RE: SUPPORT South Orange County Reliability Enhancement, as Proposed by SDG&E

**Figure 1:
SOCRE Project
Design Revisions**

Attachment B – Proposed Mitigation Measure Revisions and Technical Corrections & Clarifications
 South Orange County Reliability Enhancement Project
 SDG&E Comments on Draft Environmental Impact Report

Figure 2

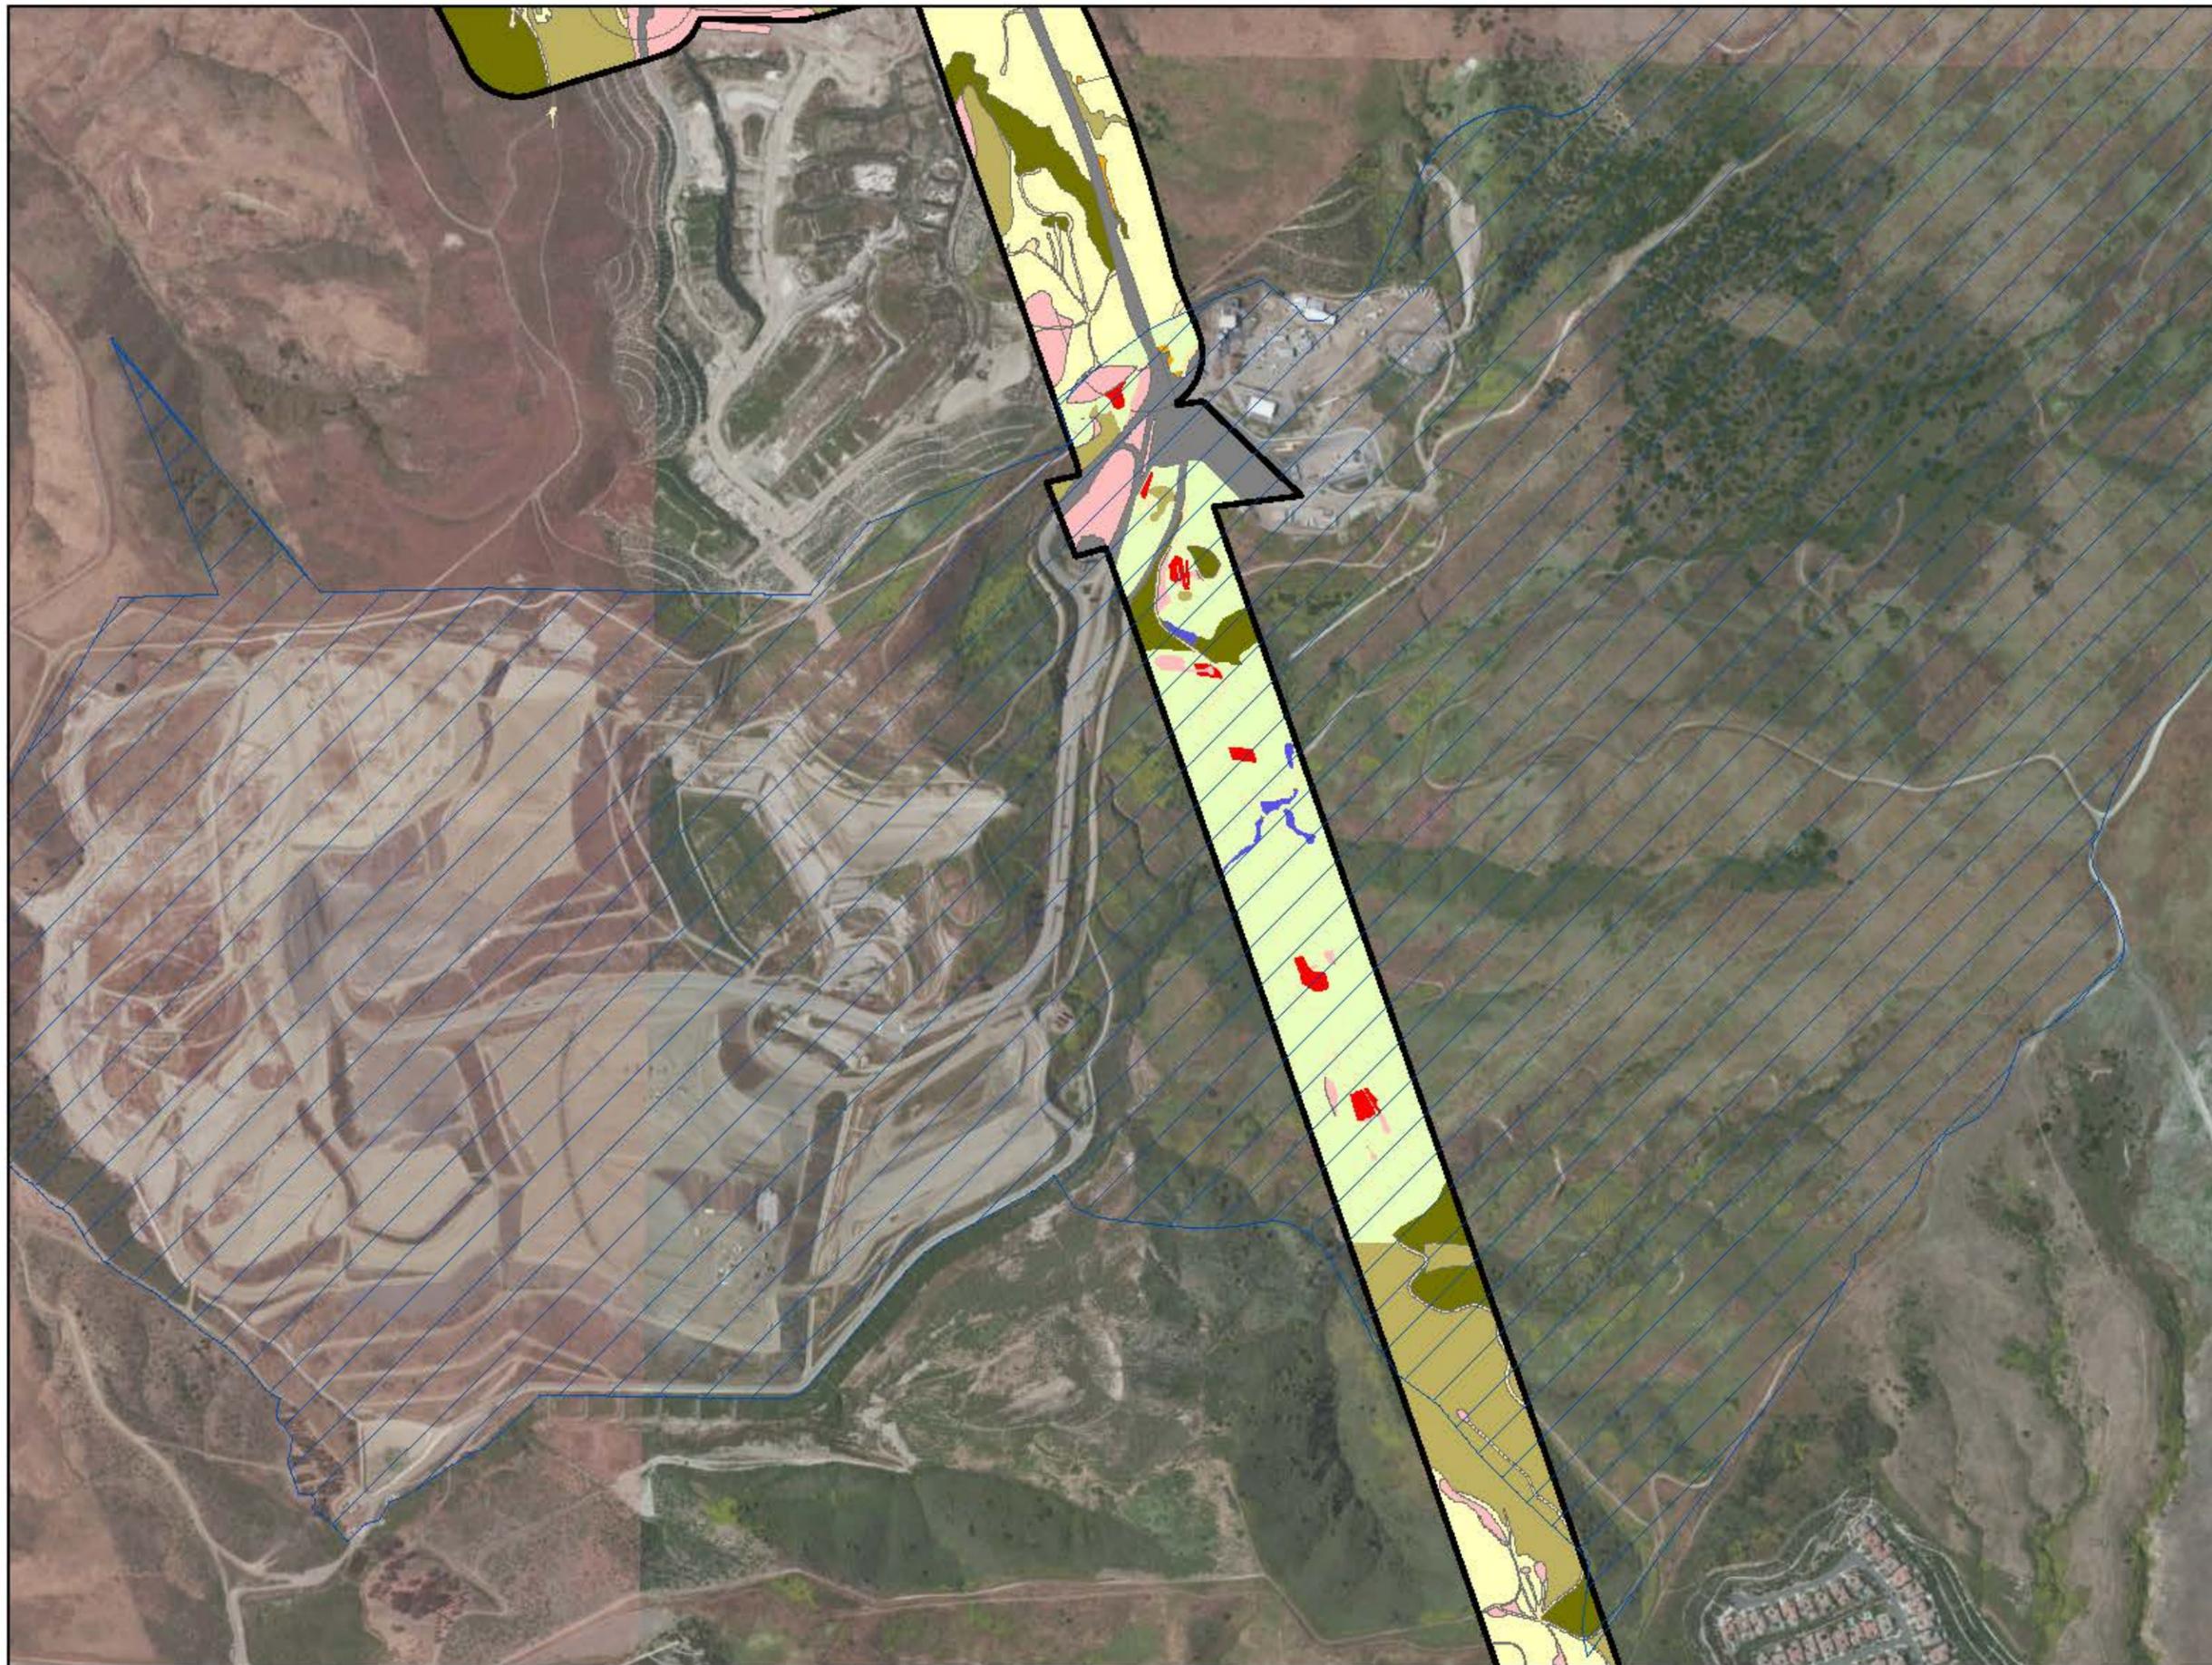
Notes:
¹Note that some of the ruderal vegetation impacts are within polygons mapped by the United States Fish and Wildlife Service (USFWS) as “Potential Development” (See Figure 2) and that these areas should not be reclassified as simply NNG, but should be considered impacts to non-sensitive ruderal vegetation that has been planned for potential future development by the applicable resource agency.
²The Draft EIR (Table 4.4-6) did not list impact acreages for non-sensitive vegetation, therefore impact acreages are listed from the PEA for comparison to the revised Proposed Project impact areas.

25.	4.4.1.2	4.4-5	Table 4.4-2	Based on the approved Orange County Southern Subregional HCP (OCSSHCP), the GIS Preserve layers provided by the USFWS has revealed that an area previously categorized as “ruderal” vegetation and reclassified in the Draft EIR as non-native grassland is designated as “Potential Development.” The GIS layer from the USFWS is based upon future planning in the area of the OCSSHCP and one large area has been classified as “Potential Development,” specifically in the area of La Pata Road and the Prima Deshecha Landfill- (Proposed Project Segment 3. The GIS data for the Orange County Southern Subregional HCP was recently provided to SDG&E by the USFWS Carlsbad office. This information is a basis for reducing impacts to what has been designated in the Draft EIR as a sensitive habitat (non-native grassland). This also addresses BR-6 which calls for coordination within Preserve areas to reduce conflicts with an adopted Habitat Conservation Plan (HCP).	Footnote 2: Vegetation classified in Appendices L-1 and L-2 as “ruderal” areas has been reclassified to non-native grasslands or appropriate contiguous habitat.	<u>Footnote 2: Vegetation classified in Appendices L-1 and L-2 as “ruderal” areas has been reclassified to non-native grasslands or appropriate contiguous habitat, except where such areas are both noncontiguous and repeatedly disturbed or overlap with USFWS planning areas designated as “Potential Development.”</u>
